REQUEST

Current Zoning: MUDD-O (mixed use development, optional)
Proposed Zoning: MUDD-O SPA (mixed use development, optional, site plan amendment)

Approximately 2.58 acres located on Carnegie Boulevard, near Torp Landing Boulevard and Charmeck Palisades Drive, west of Barclay Downs Drive.
(Council District 6 - Bokhari)

The petition proposes development of an office building with retail uses on the vacant parcel of land, west of Capitol Towers in the SouthPark area.

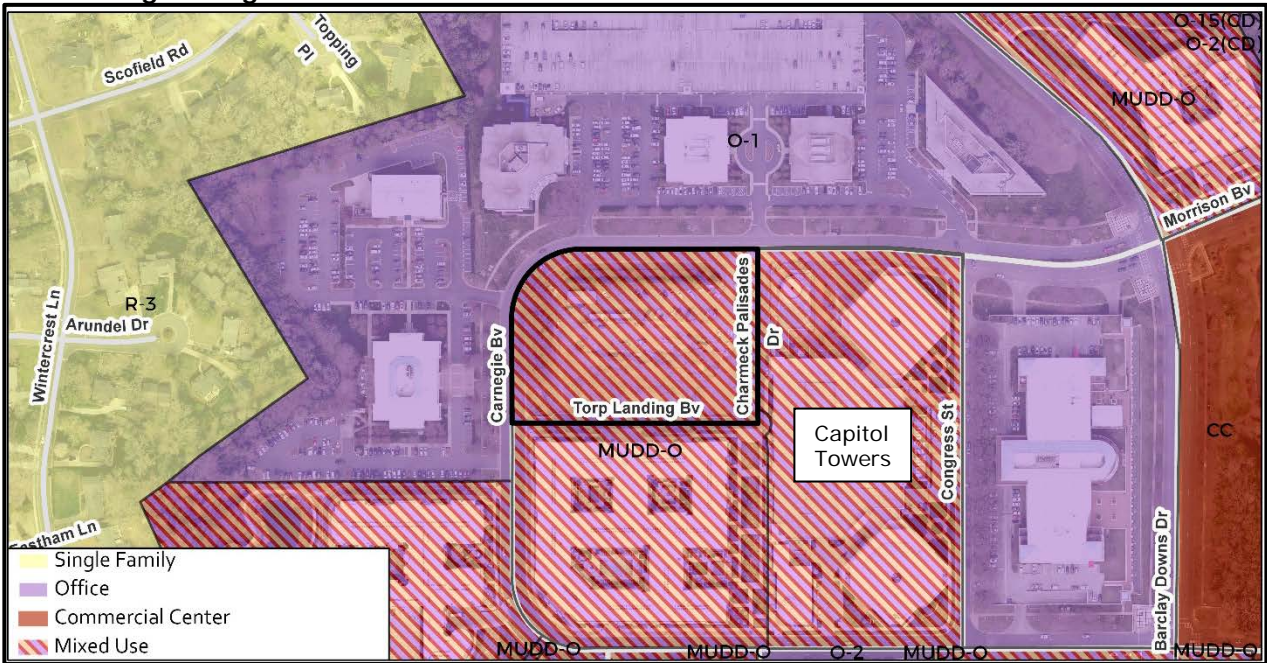
1. ~~Amend the building perspective views to annotate key architectural design elements committed to as part of the rezoning.~~ Addressed.

2. ~~Update the site plan and conditional notes to show an eight-foot planting strip and six-foot sidewalk along Torp Landing Boulevard to mirror the current existing opposite side of the road.~~ Addressed
3. ~~Amend the site plan and notes to clarify the commitment to construct the cultural loop along Charmek Palisades Drive.~~ Addressed
4. ~~Remove conditional note V.c. until CDOT and developer work out the agreement of what improvements can be substituted for contributions and agree on a contribution.~~ Addressed
5. ~~Revise the site plan to show a two-foot easement behind sidewalk outside of the right-of-way along Carnegie Boulevard.~~ Addressed

6. ~~Add a note to the Carnegie Street Elevation and the third Perspective View graphics to clarify the intent of the graphics is to show relationship to existing surrounding development.~~ Addressed.
